## **2 MINOR MODIFICATIONS TO THE PROJECT**

### **2.2 SUMMARY OF MODIFICATIONS TO THE PROJECT DESCRIPTION**

## DEIR/DEIS Exhibit 2-7

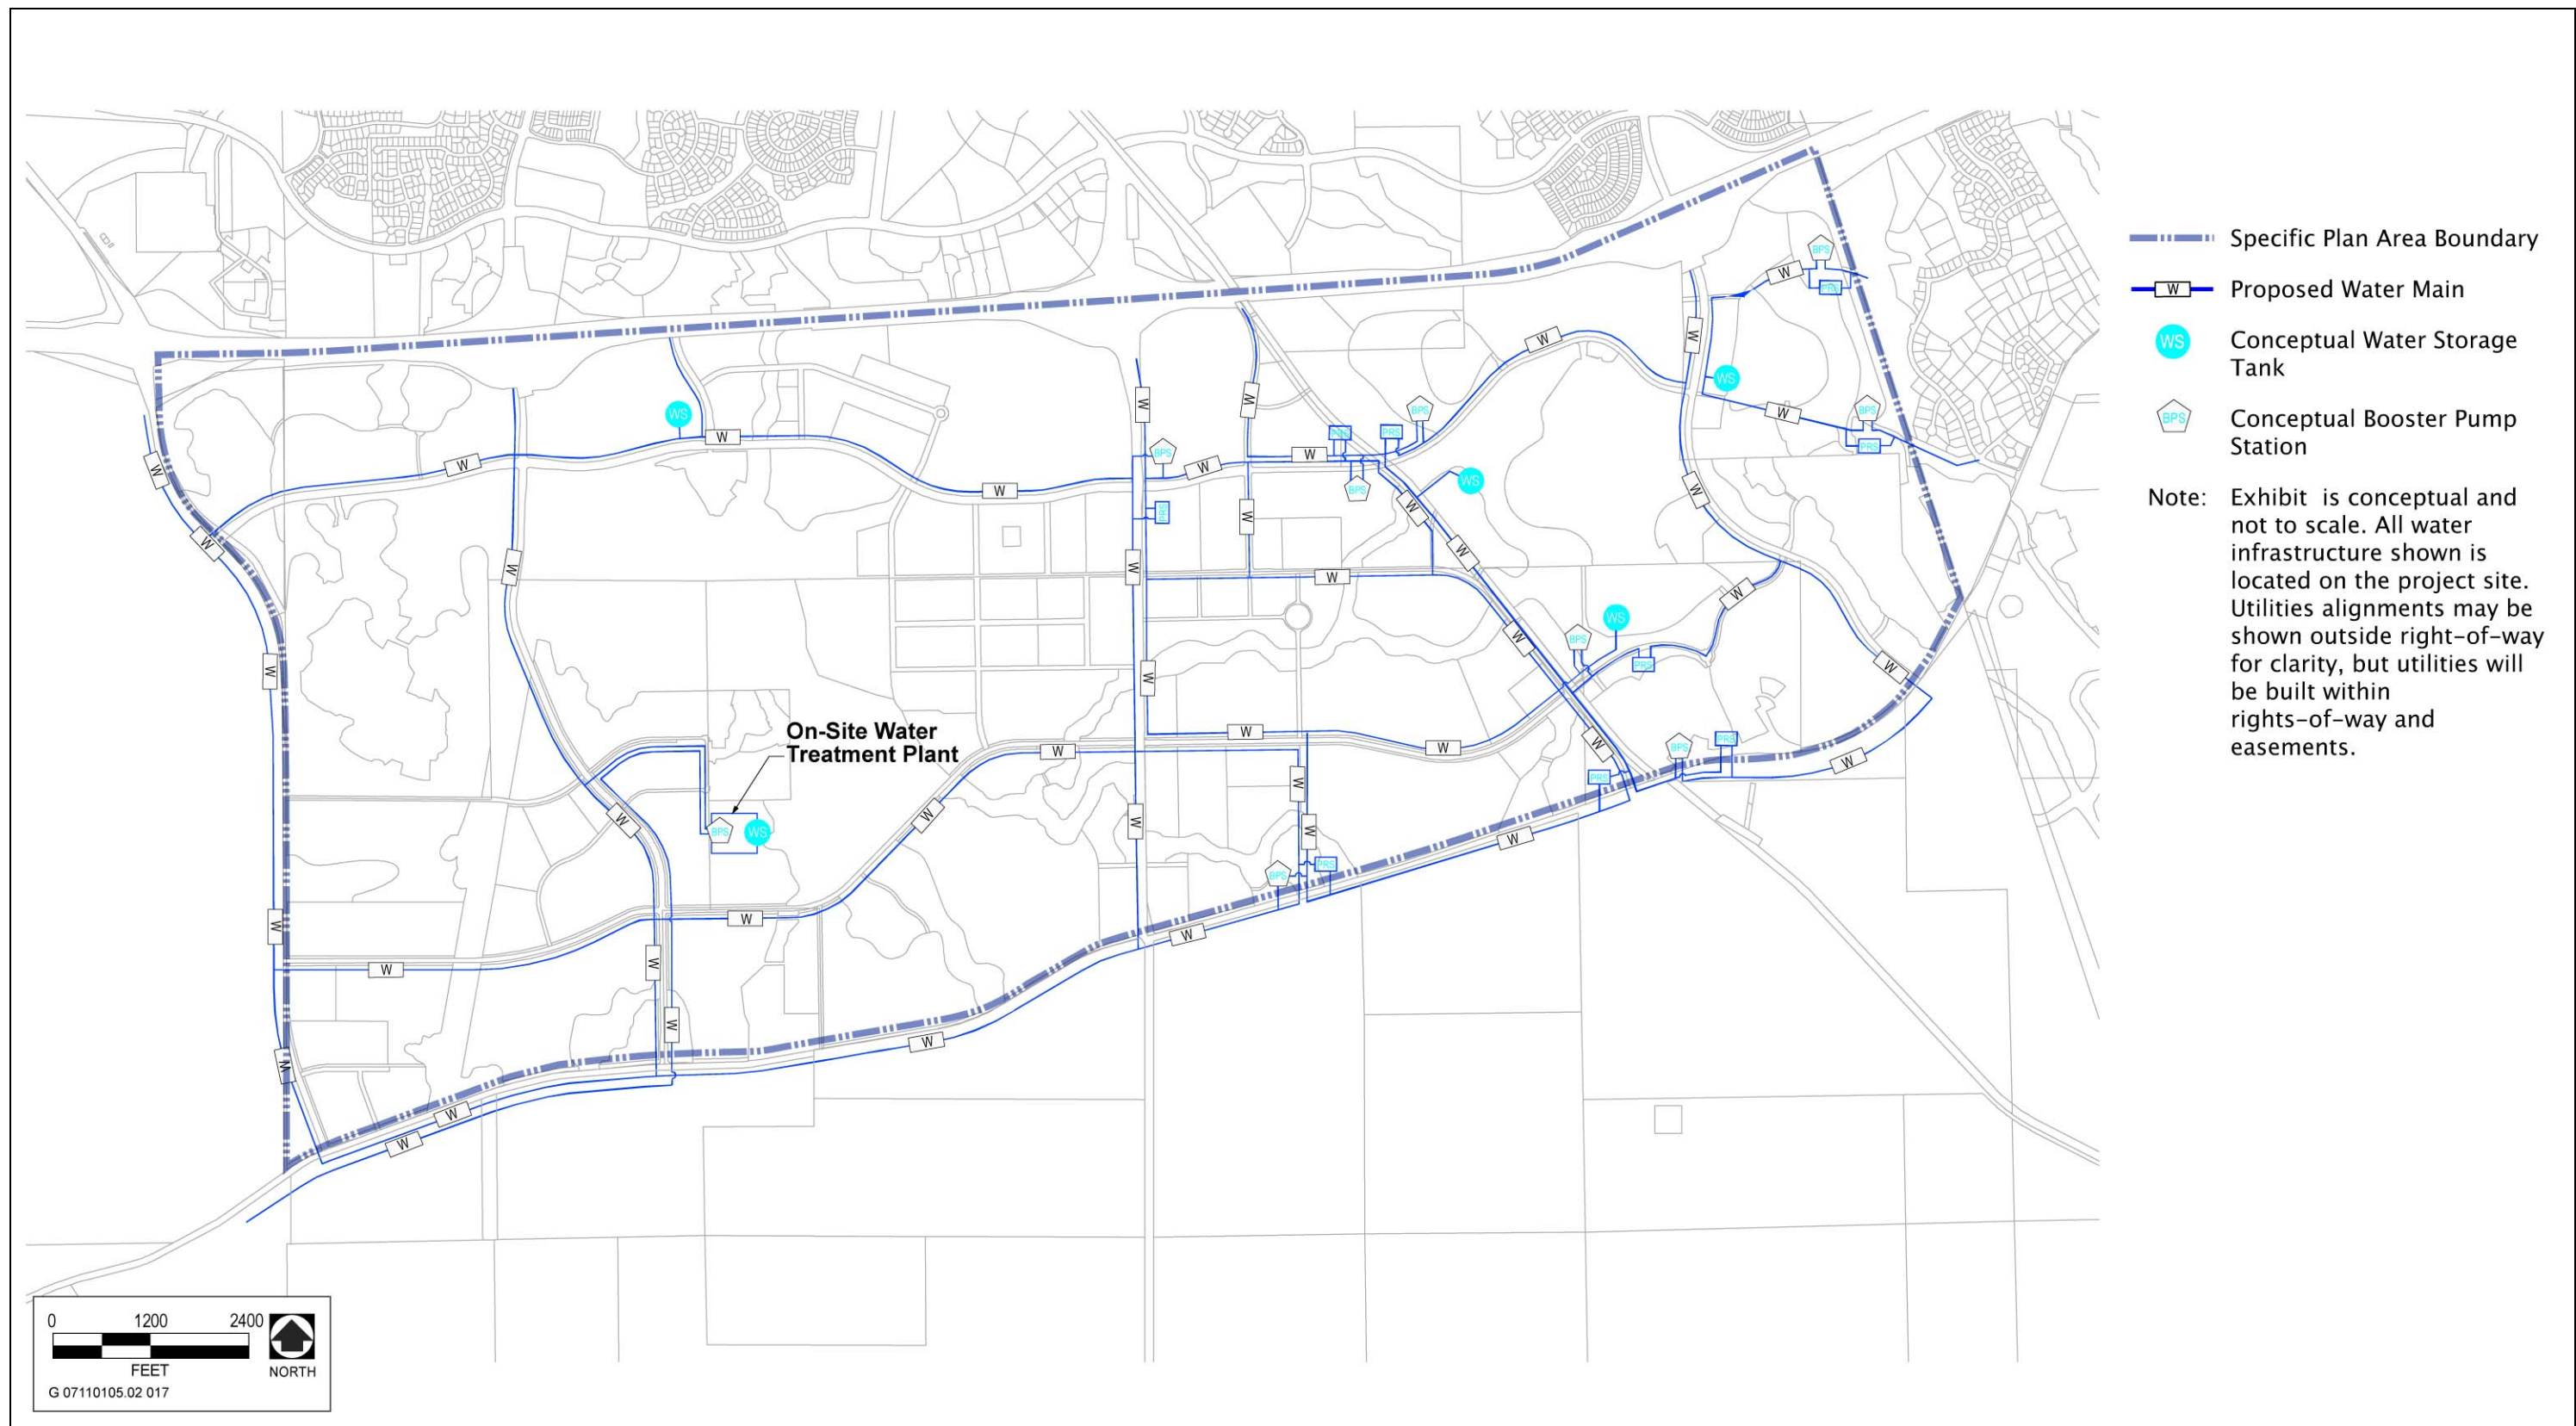
Since the DEIR/DEIS was prepared, the City has determined that its “preferred” location for the WTP is within the SPA at the location shown on DEIR/DEIS Exhibit 2-7 and as shown in Figure 12.1, “Backbone Water and Nonpotable Water Infrastructure” in the Folsom Plan Area Specific Plan, attached as Appendix N to the DEIR/DEIS.

## Exhibit 2-3A

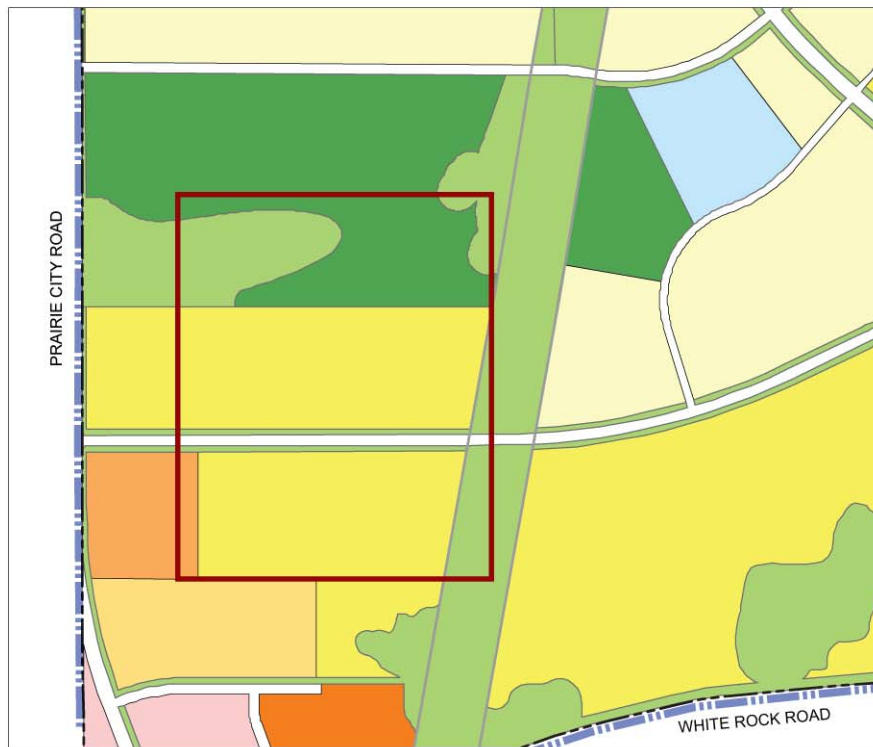
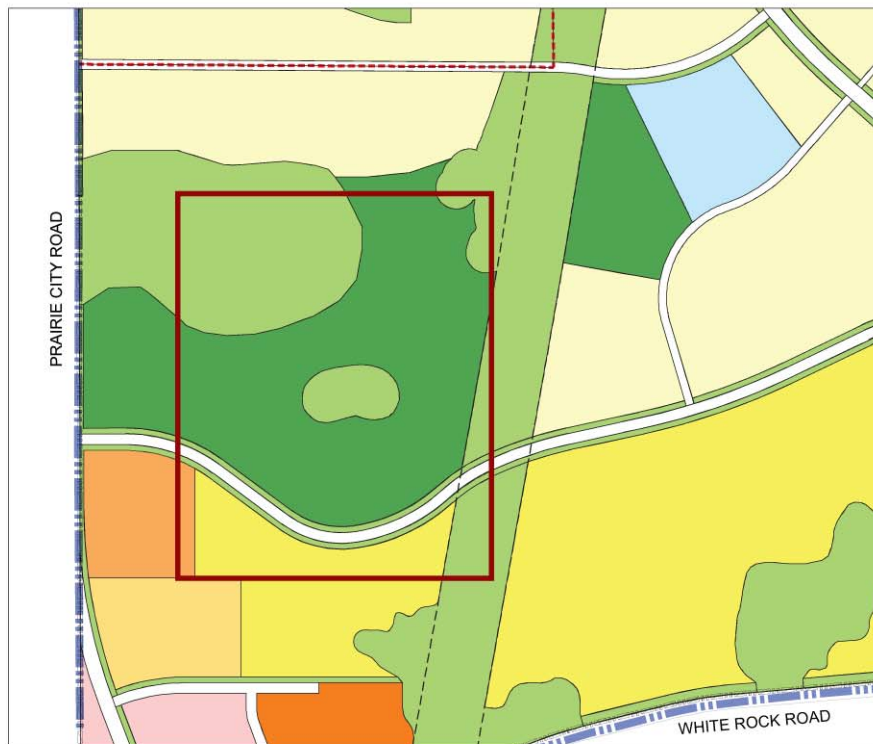
The Conceptual Land Use Plan presented in Exhibit 2-3 of the DEIR/DEIS has been altered slightly for the proposed Community Park West in the vicinity of “Area 40,” on the southwestern portion of the SPA. Exhibit 2-3A, below, provides a comparison of the land use plan for the Area 40 vicinity as presented in the DEIR/DEIS, and the revised land use plan. The proposed land use changes would add about 3.5 acres of Park, about 18 acres of Open Space, and about 23 acres of Single Family designation compared to the acreages in the Land Use Plan presented in the DEIR/DEIS. The acreage of the Single Family High Density designation would be reduced by about 39 acres, Multi-family Low Density would be reduced by about 5 acres, and Multi-family Medium Density would be reduced by less than 1 acre compared to the Land Use Plan presented in the DEIR/DEIS. (Totals may not be equal due to rounding and changes to the right-of-way needed for Street “A.”) These proposed changes represent an overall reduction in density and intensity compared to the land use plan described in the DEIR/DEIS, and therefore would not increase level of impacts beyond those evaluated throughout the DEIR/DEIS, nor would any new impacts occur.
